Bid Bulletin #02

PROJECT: Educare of Winnebago
Bid Package #04
Winnebago, NE

ADDENDUM G

Educare Winnebago
Winnebago, Nebraska
RDG Project No. 2010.175.00, File 35.1

2010.175.01
 45.2
 SDA-009

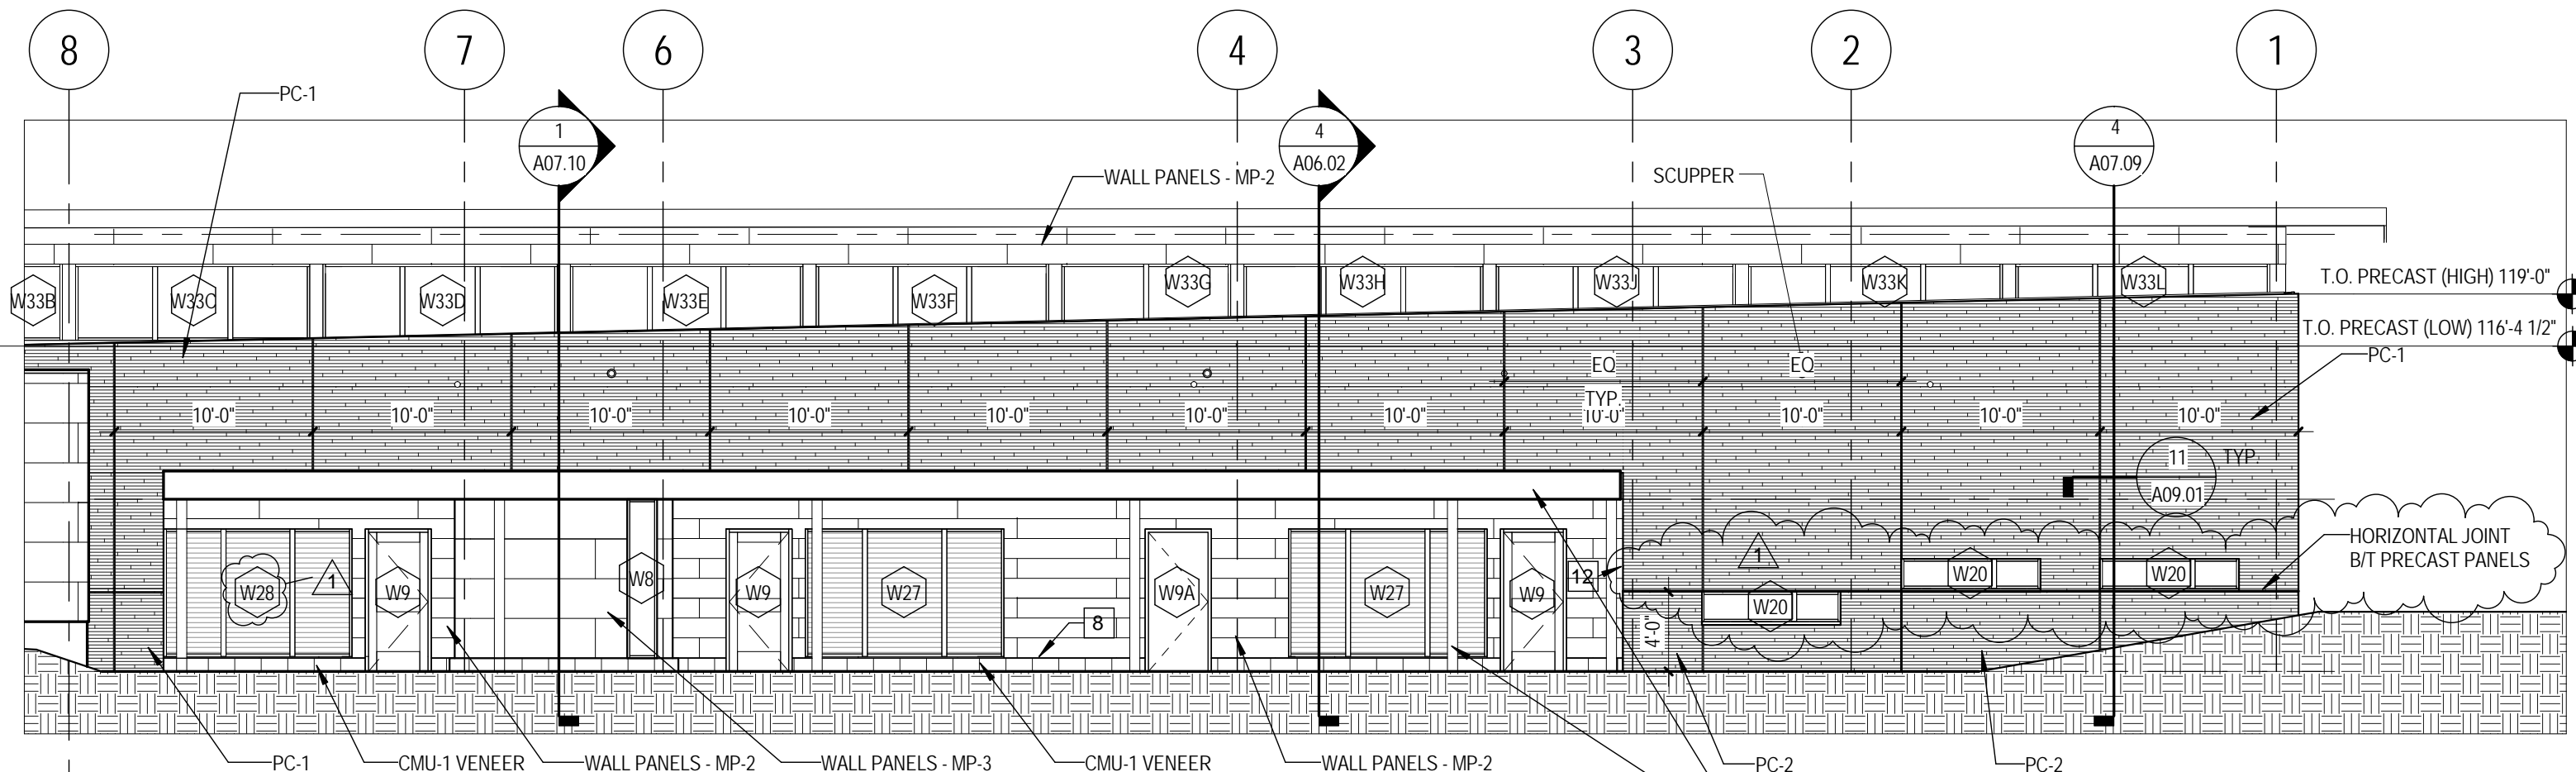
- A. Elevation 1, East: See attached Supplemental Drawing SDA-009 with the following revisions:
1. Revise one instance of W9 reference (to right of Grid 18) to read **"W7."**

2. Revise all occurrences of "FACIA" in notes to read **"FASCIA."**
 3. Add locations for through-wall scuppers and add the note **"OVERFLOW SCUPPER (TYPICAL) – SEE MECHANICAL."**

2010.175.01
 45.2
 SDA-010

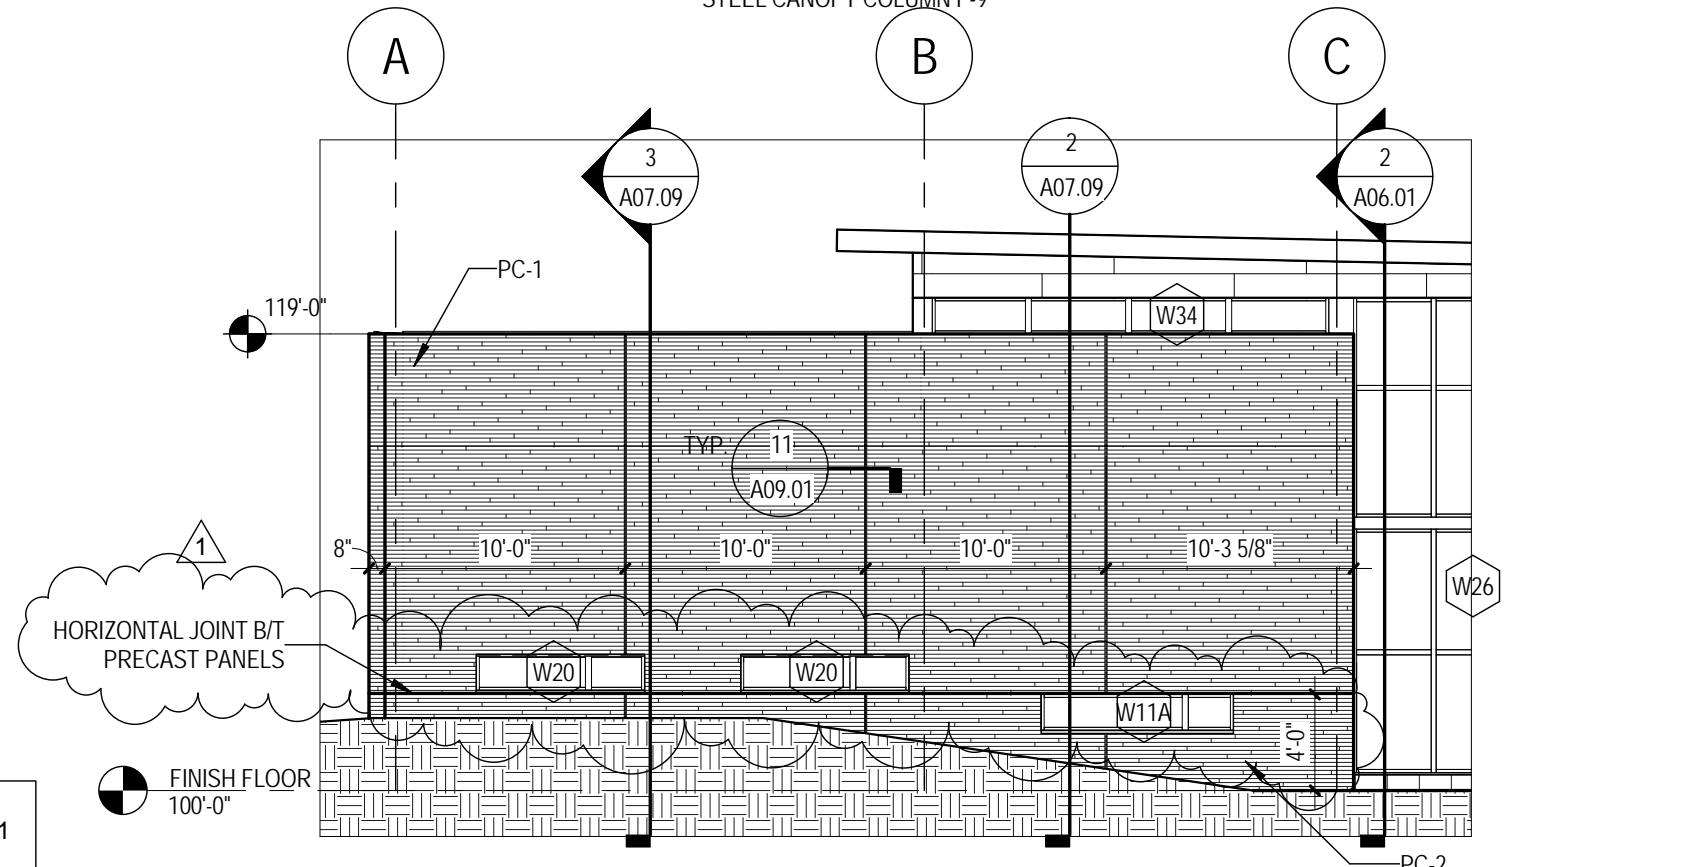
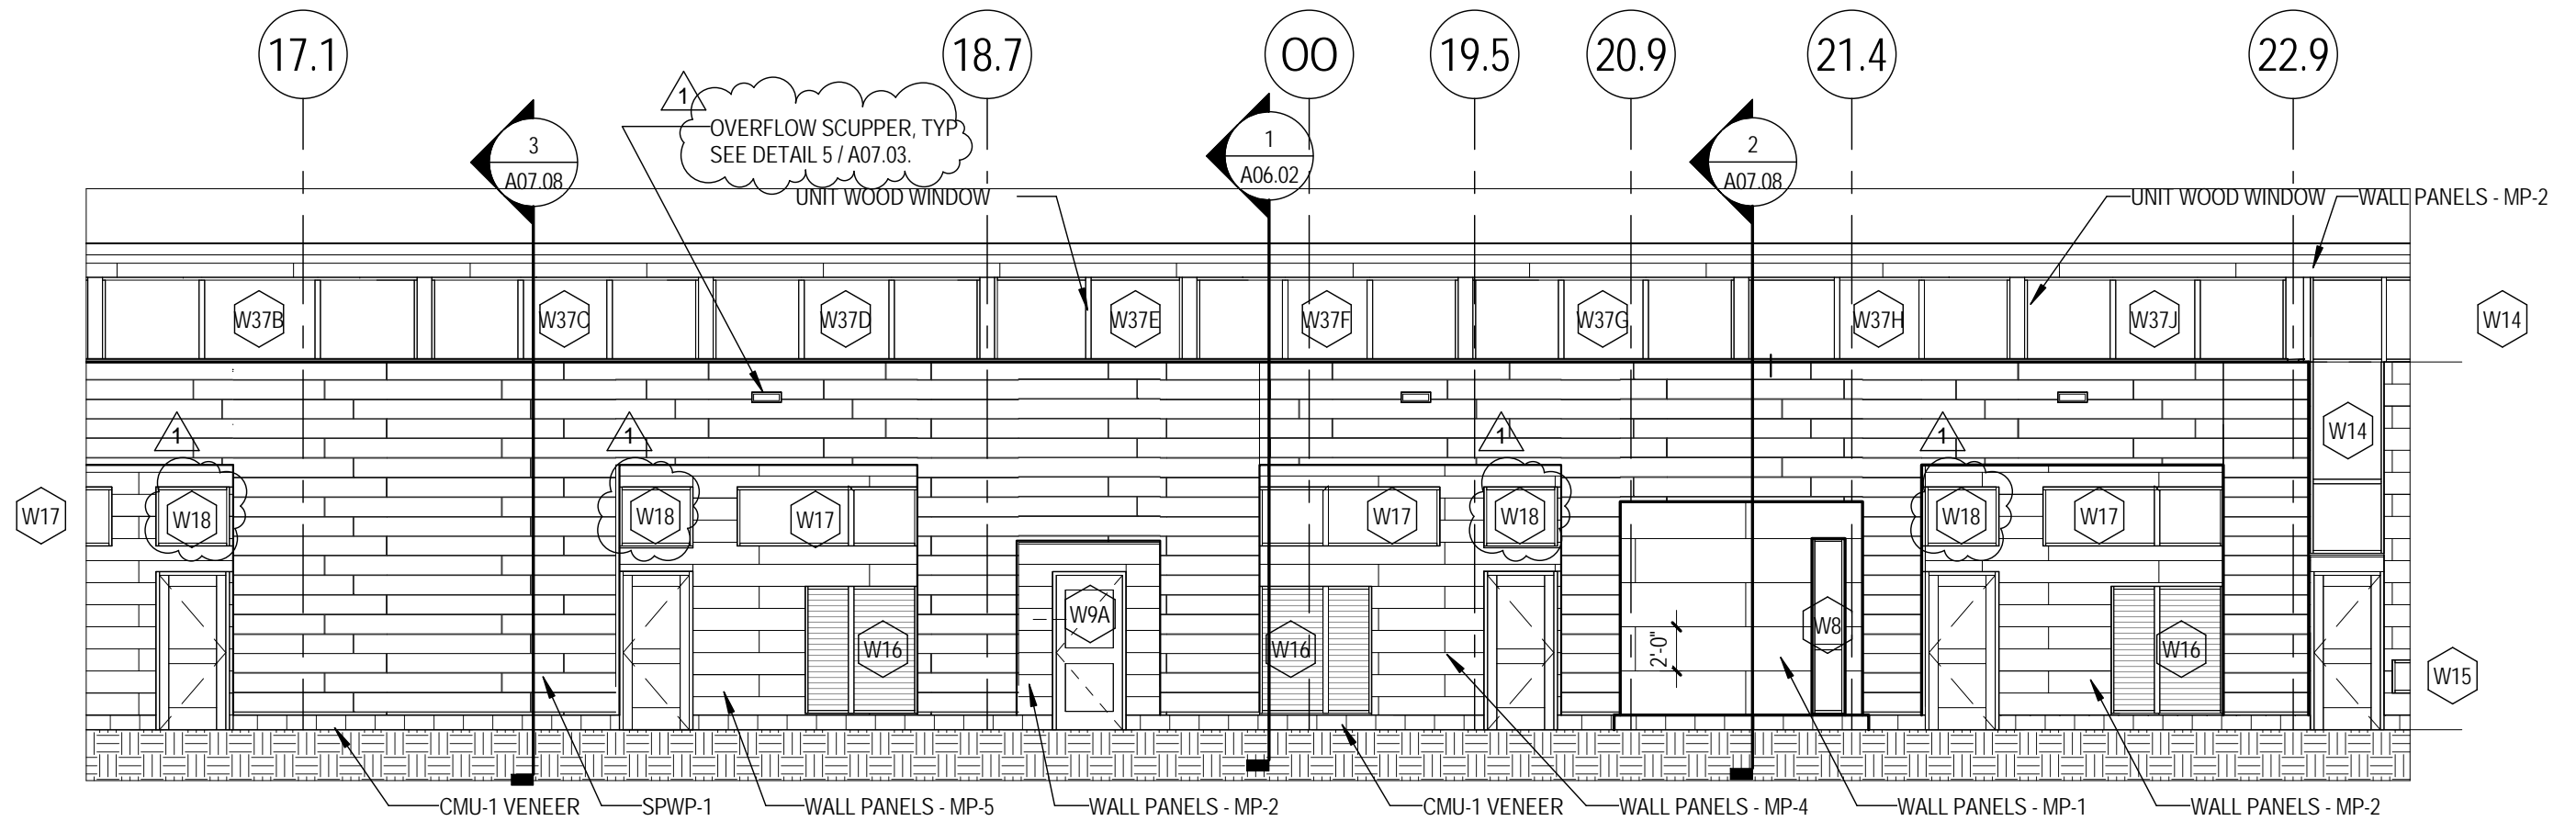
- B. Elevation 2, East: See attached Supplemental Drawing SDA-010 with the following revisions:
1. Revise one instance of W30 referenct (to left of Grid 7) to read **"W28."**

2. Add horizontal line to define panel joint between precast panels.
- C. Elevation 8, Northwest: See attached Supplemental Drawing SDA-010. Panel revision includes addition of horizontal line to define panel joint between precast panels.

2010.175.01
 45.2
 SDA-011

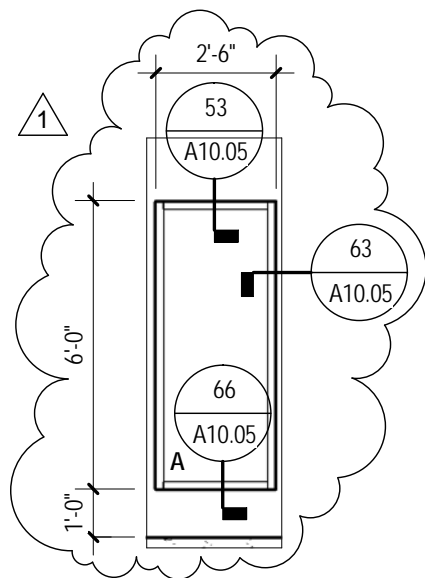
- A. Elevation 1, West: See attached Supplemental Drawing SDA-011 with the following revisions:
1. Add note reading **"OVERFLOW SCUPPER, TYP. SEE DETAIL 5 / A07.03."**
 2. Revise window tag locations for clarity.
- B. Exterior Material Legend, Wood Siding: Revise line reading "WD-1: Wood SOFFIT SIDING: DESIGNED TO CAMBIA SHIPLAP RED OAK" to read **"WD-1: HARDBOARD SIDING, SEE SECTION 062013."**

DATE 12/13/12
 MODIFICATION: ADDENDUM G
 REF'D SHEET: A10.01
 REF'D DETAIL: F20

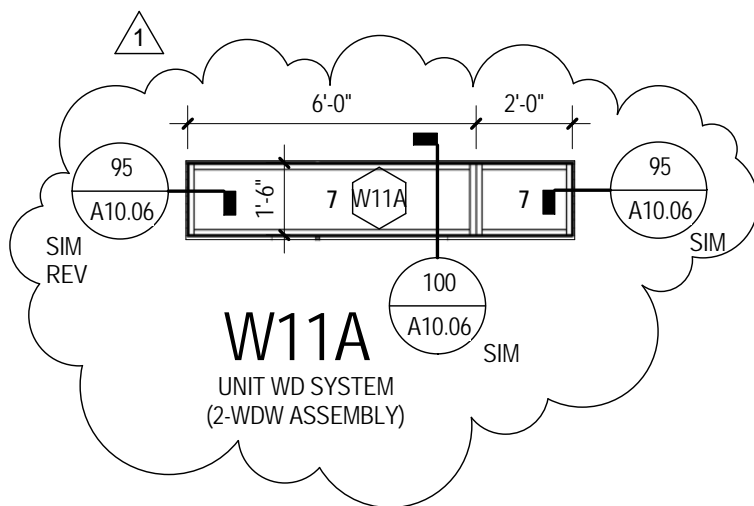
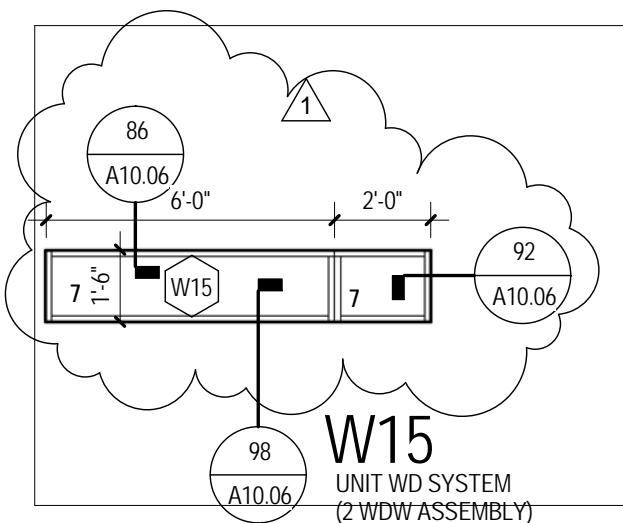
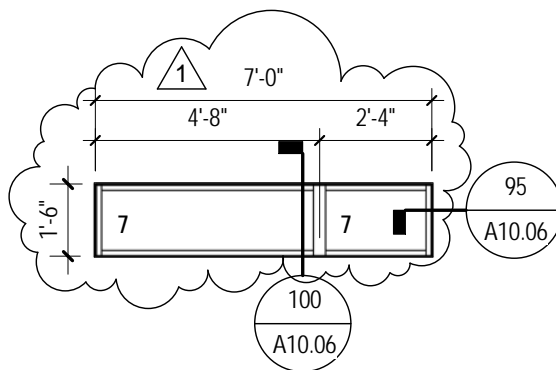
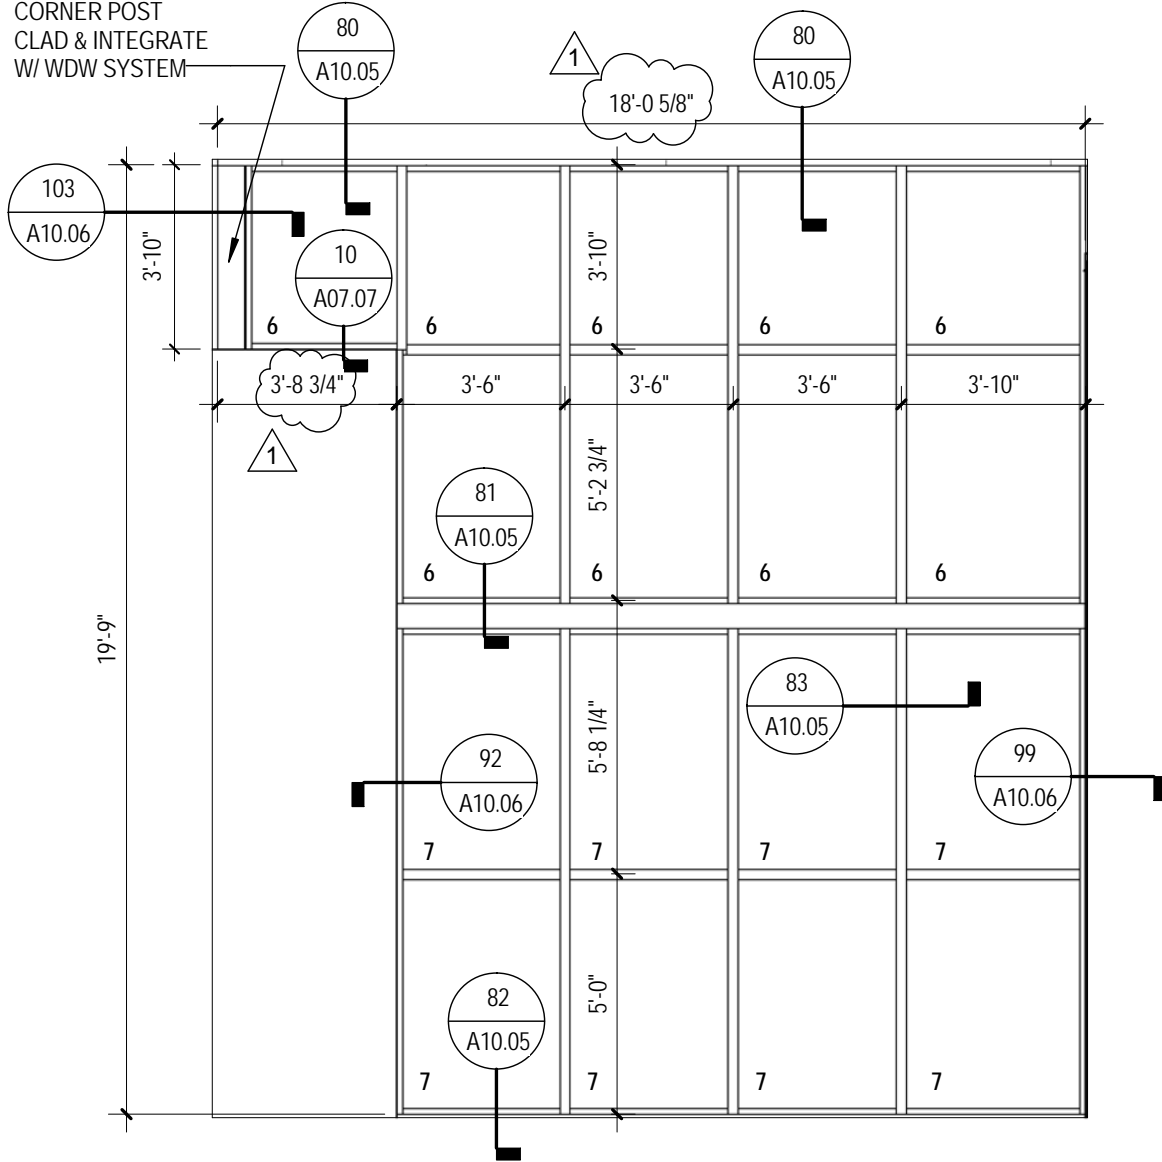
GGD-10 Sheet A10.01, Door Schedule & Types, F20: Revise per attached Supplemental Drawing SDA-012.

- A. W11A: Revise per attached Supplemental Drawing SDA-012.
- B. W11B: Add Glass Type "7" to two panes.
- C. W12: Revise per attached Supplemental Drawing SDA-013.
- D. W15: Revise per attached Supplemental Drawings SDA-012.
- E. W20: Revise per attached Supplemental Drawing SDA-012.
